World Forum for Harmonization of Vehicle Regulations

Other UN Regulations:

UN Regulation No. 10 (Electromagnetic compatibility)

Proposal for Supplement 2 to the 06 series of amendments to UN Regulation No. 10

"Figure 1

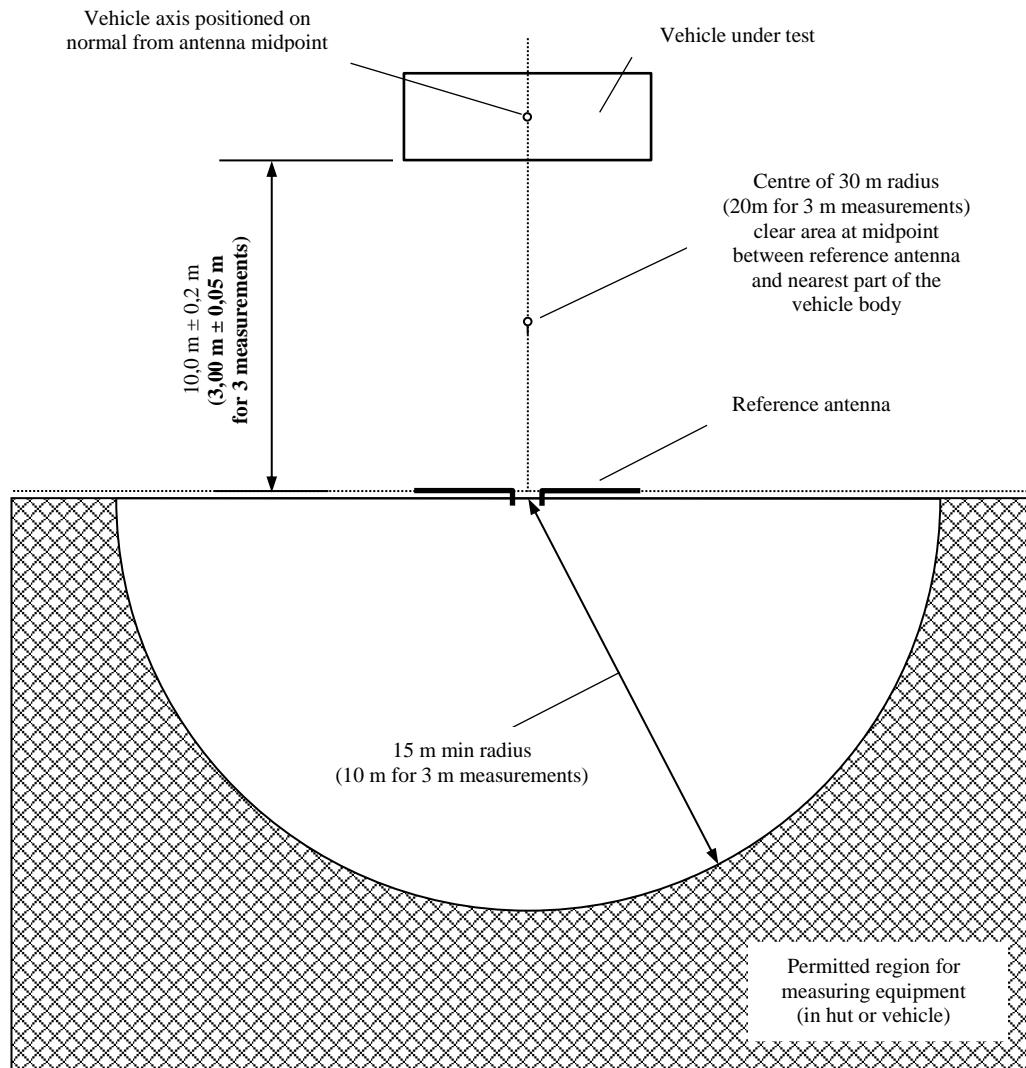
Annex 4 - Appendix 1, Figure 1, amend to read:

1. In Figure 1 of Annex 4, Appendix 1, the alternative 3 m antenna distance is missing. Standard CISPR 12 prescribes the alternative 3 m antenna distance in the note below the similar figure: "*The 10,0 m \pm 0,2 m dimension may be changed to 3,00 m \pm 0,05 m in accordance with 5.2.3.2 and 5.2.3.4.*" The proposal formally corrects Figure 1.

Clear horizontal surface free of electromagnetic reflection delimitation of the surface defined by an ellipse
